Technical Meeting

Goliad Exemption

8-16-12

Issues with the latest submissions

Figure 4.7. Water level drawdown and recovery in Troll observation wells for the PTW-6 test.

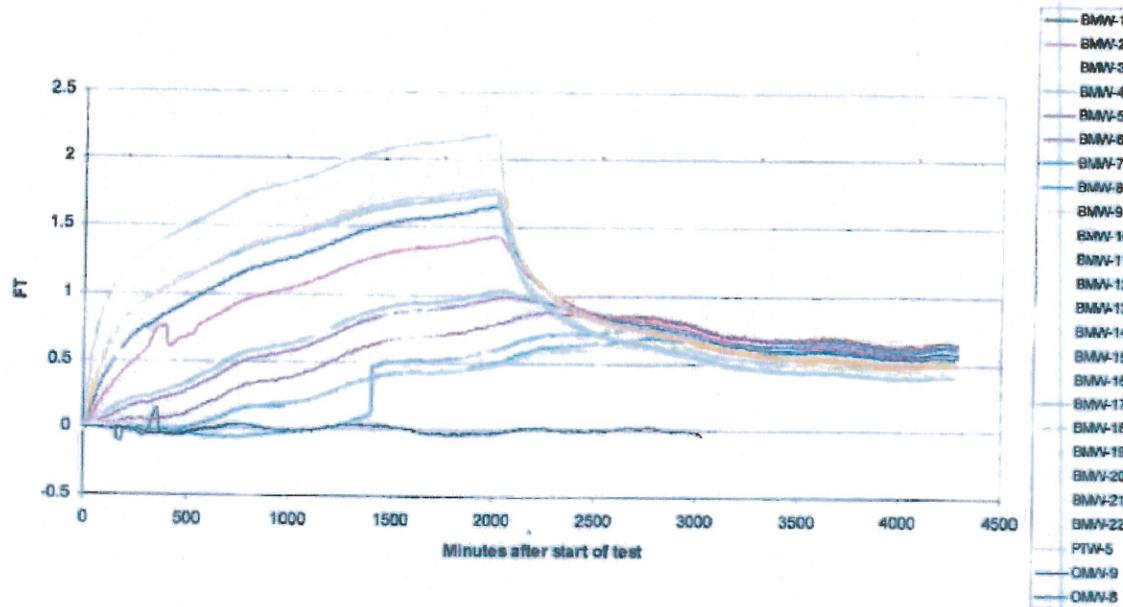
Results of PTW-6 pump test

- Shows good communication with monitor well ring
- Indicates hydraulic isolation with OMW-9 completed in A sand
- Results of second OMW-8 is not clear

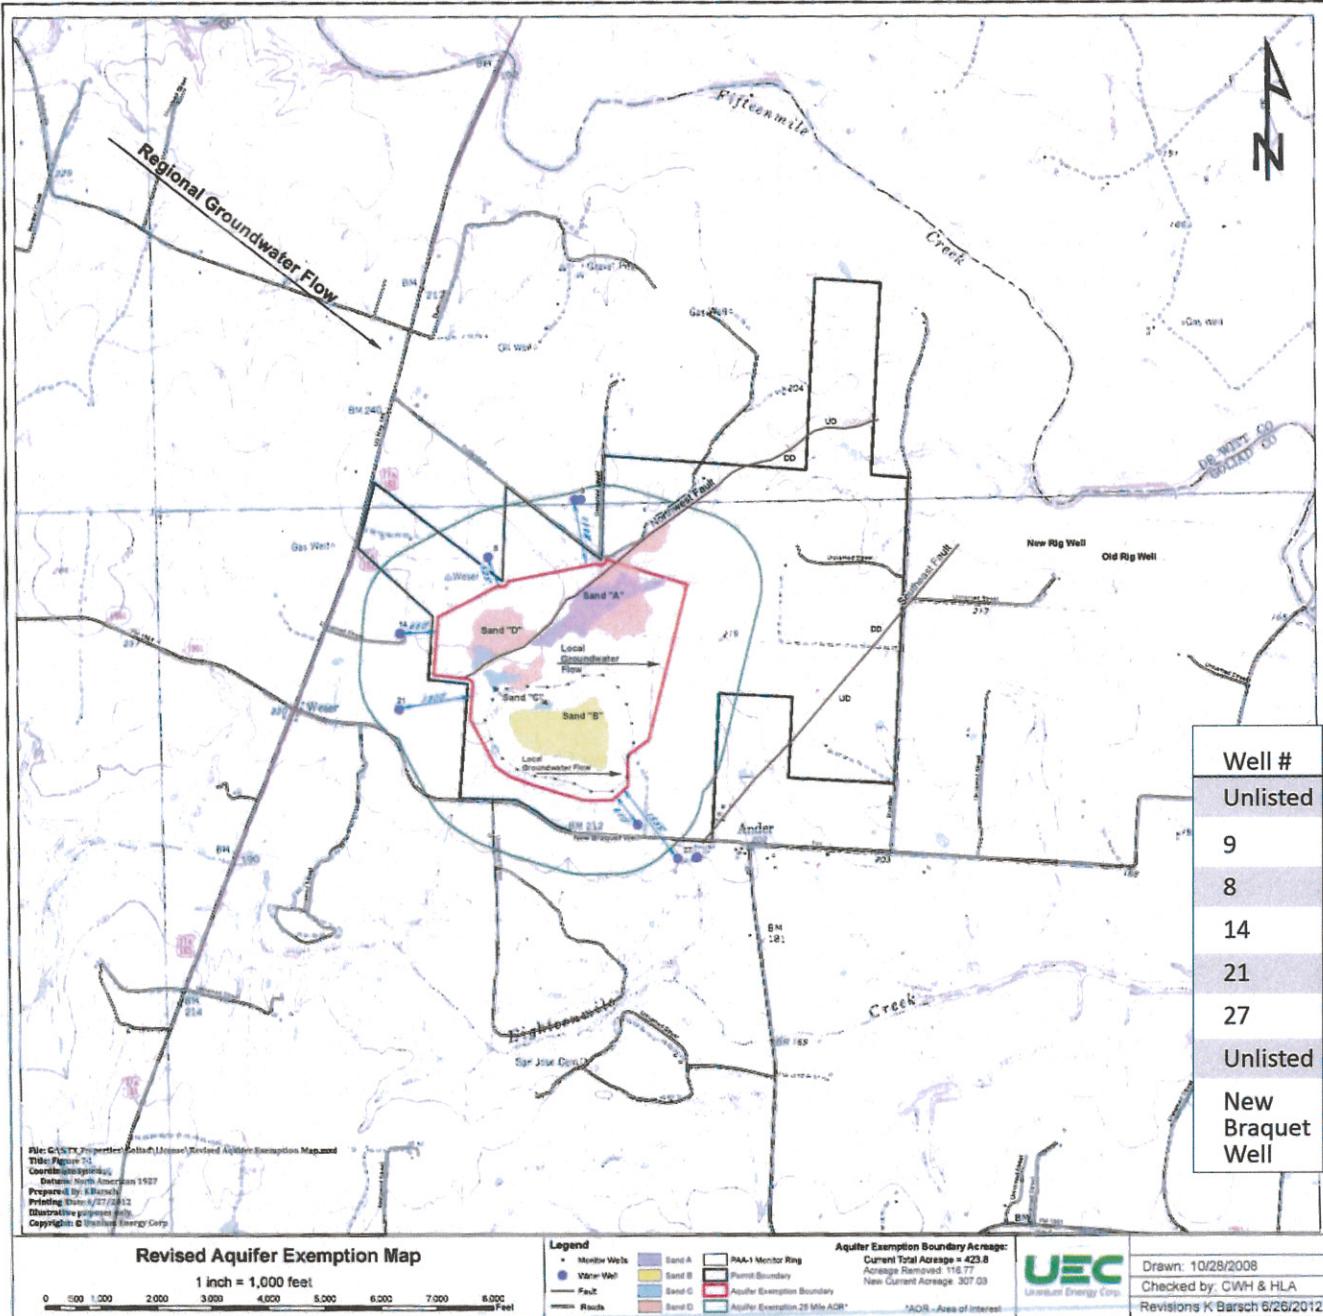
Can pump tests be relied upon to find hydraulic isolation between A and B sands exists?

- Distance between pump test well PTW-6 and OMW-9 showing good isolation is approximately 125'
- There is a much greater distance between the test and down gradient wells of concern
 - Distance to the Braquet well is approx. 1400'
 - Distance to the Church wells is approx. 2300'
- Pump test using PTW -6 is simply too far away to extrapolate results to wells of concern
